110 Jervois Quay. Resource Consent Application. CPTED Statement. Addendum 22 August 2022.

Herewith an addendum to the CPTED Statement in support of the Resource Consent Application for 110 Jervois Quay Wellington, prepared previously (17 February 2022).

FIG. 3. Ground Floor (Rev).

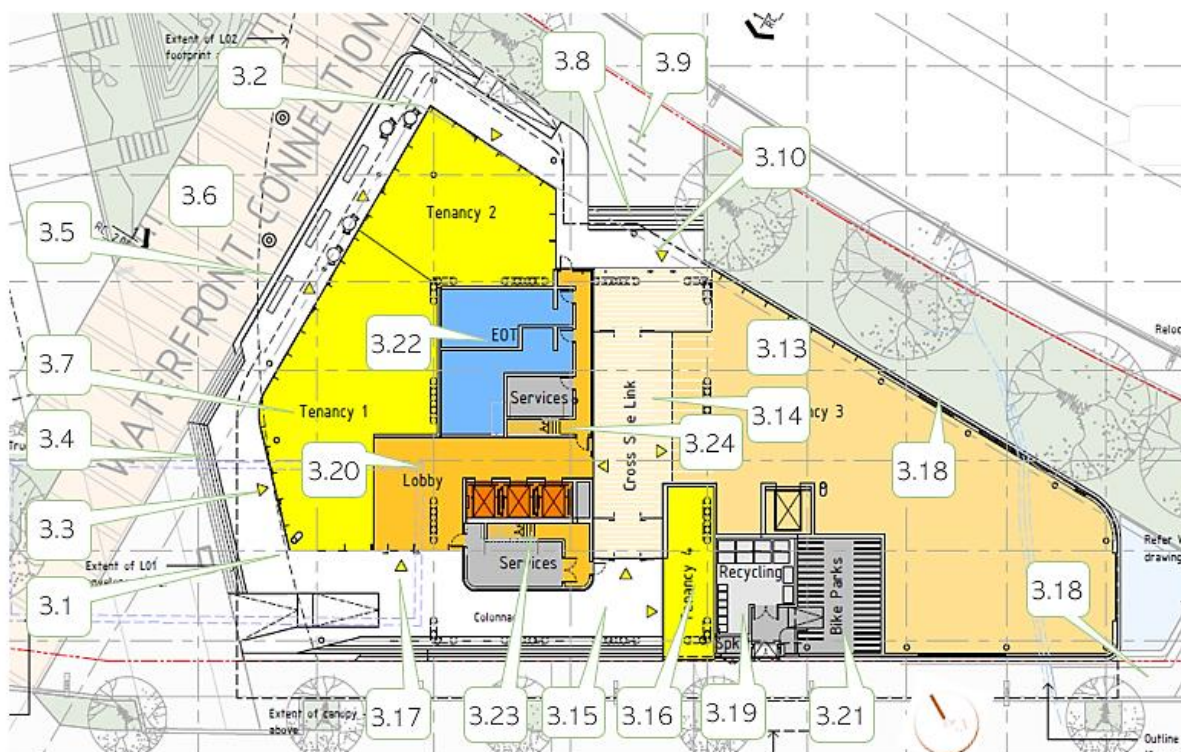
- ✓ Clear views remain through and around the west and north corners [3.1], [3.2] of the building as do slim columns [3.3] to eliminate concealed lurking.

- ✓ Unchanged western steps [3.4] and plinth edge [3.5] continue to be activated by the waterfront connection [3.6], Tenancy 1 [3.7], and a north facing aspect.

- ✓ Generous external steps [3.8] have been simplified and continue to maintain separation between people in transit and those who have paused.
- ✓ The public cycle rack [3.9] remains in clear view for natural supervision.

- ✓ Simple, legible, and wide entrance-ways [3.10], [3.15] with supervision from adjoining tenancies, continue to discourage soiling and unwanted occupancy/rough living often associated with unactivated, smaller entry/exit recesses.

- ✓ The northern and southern entrances [3.10], [3.15] in conjunction with the alignment of the simplified Cross Site Link [3.14] continue to provide strong, logical and legible connections to the proposed crossing zone over Jervois Quay to link with the Waterfront, and to Opera House Lane respectively.

- ✓ Changes to the ground floor simplify the lift lobby and assist with maintaining a controllable line between it, as semi-public/semi-private space, and the public space zone of the Cross Site Link.

- ✓ The lift lobby now has a main entrance [3.17] directly off the southern colonnade. This provides two entry points to the lobby.
- ✓ Access to both sets of core stairs [3.23], [3.24] remains securable, and the replanning has eliminated a CPTED concern raised previously for resolution in Detailed Design.

- ✓ There are no changes to the edge conditions around the perimeter of the east side of the building [3.18].
- ✓ There are no material changes to upper and typical floors.
